Certificate of Appropriateness

918 N Vel R Philips Avenue

Removal of three windows on east elevation that are within the elevator shaft. Infill with brick recessed two inches. Remove two doors – one on third floor, one on fourth floor – on south elevation. Infill with brick recessed two inches. All infill brick to match surrounding masonry.

EXISTING EAST ELEVATION

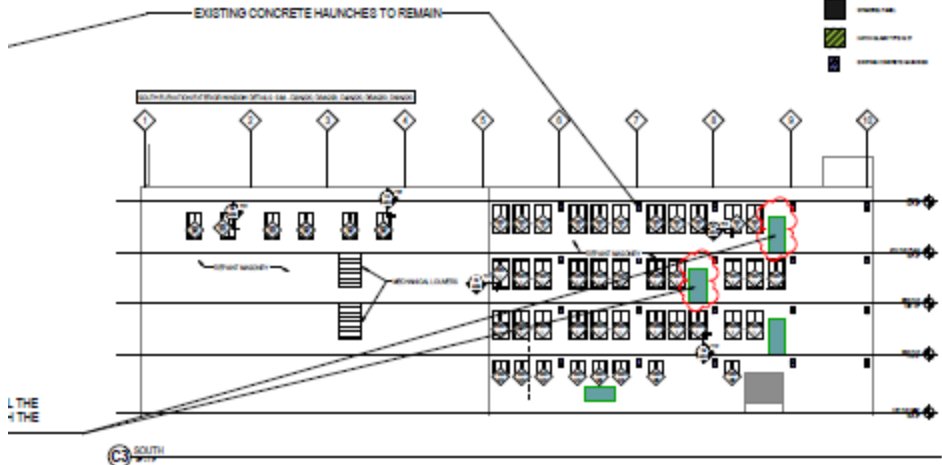
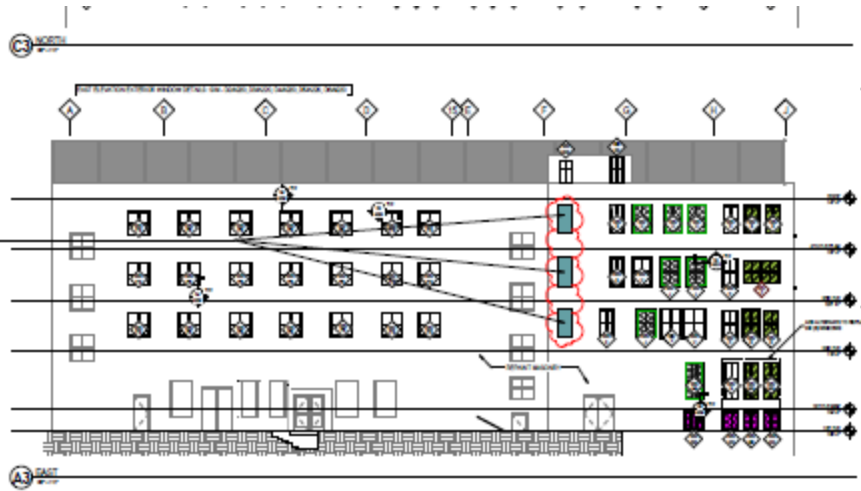
REMOVE EXISTING WINDOW AND INFILL THE OPENINGS WITH MASONRY TO MATCH THE EXISTING ADJACENT MASONRY

New masonry is to be recessed two inches from the building's exterior.

Any existing features surrounding the subject doors and windows will remain intact.
